工程名称	秦俑博物馆
地址	三义坡墓坑

说明及配电系统图

设计号 86034

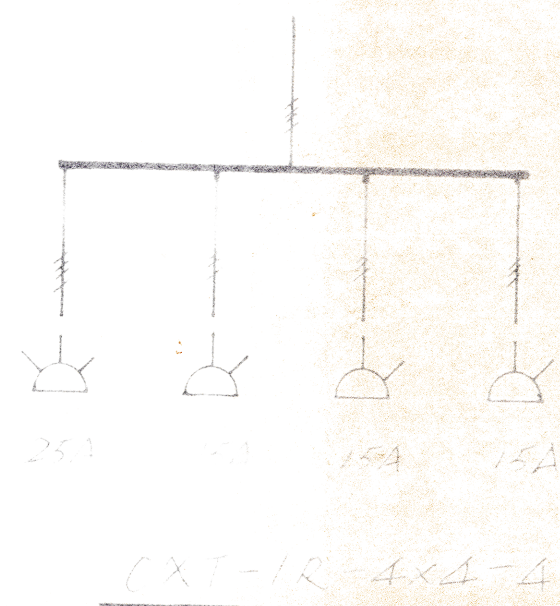
1. 根据建设单位要求将品空调电流插座及部分照明线路改动。
2. 照明配电箱按本图要求订货。插座箱均为 CXT-1C-1×4-4 型暗装箱。
3. 反风机控制箱主开关改接为 DZ10-100/330 30A, 配电回路增设两支 DZ5-50 25A 自动开关向空调机供电。
4. 图中灯具为原有灯具不变。虚线示原有穿线管, 按本图换线, 导线型号未注明时均为 BV-105 (2.5 mm²) 耐热塑料线。
5. 图中实线为新增线路, 均为 BV (6 mm²)。空调电流线路在展厅部分沿网架敷设, 引下至插座的垂直部分沿墙暗敷。透地坑插座箱线路沿围栏内坑边暗敷。
6. 三相四线插座为 380V 25A 暗插座。其余为 250V 15A 单相三极带开关暗插座。装高均为 1.6 m。
7. 原有未画出的无线路均不变, 接至配电箱的回路编号不变。
8. 接零保护线均利用敷线钢管在配电箱处接工作零线。
9. 透地坑内及屋顶部予留照明电流, 在图中要尽量注意, 尽量将负荷均布在三相上。
10. 将图 1-2 交非控制模流器换成西宝永明灯具, 并装三只于该处。
